DaimlerChrysler
India Private Limited

Service measure during next workshop visit
Replace seal at engine oil filler neck
Model 211 with OM 642 engine

WORK DESCRIPTION FOR SERVICE MEASURE

Replace seal at engine oil filler neck
Model 211

Figure 1

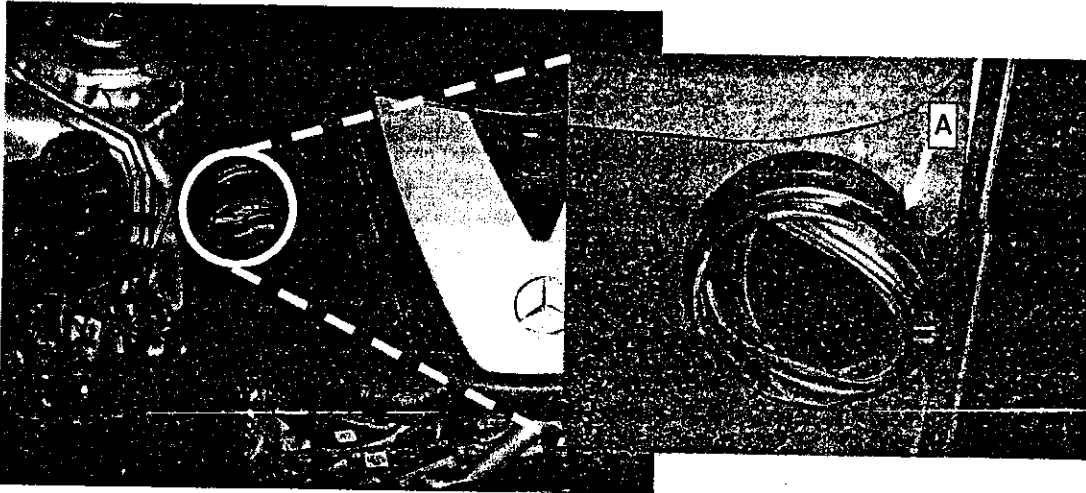
1. Remove engine cover and remove old seal (A) at engine oil filler neck opening (figure 1).

Figure 2

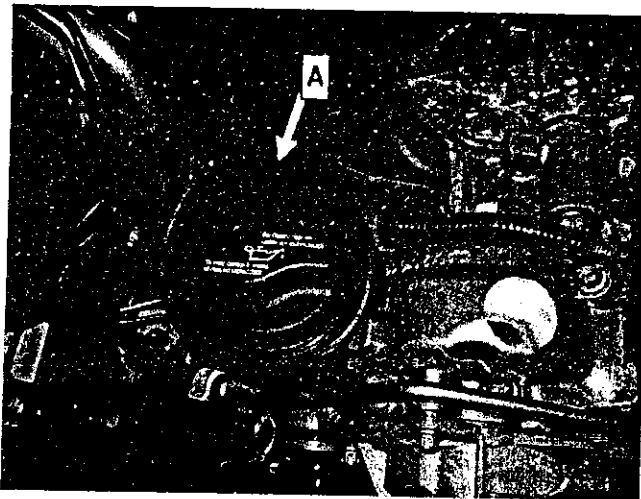
2. Install new seal (A) at engine oil filler neck (figure 2).

Quantity	Designation	Part no.
1	Seal	A 642 018 00 80 05
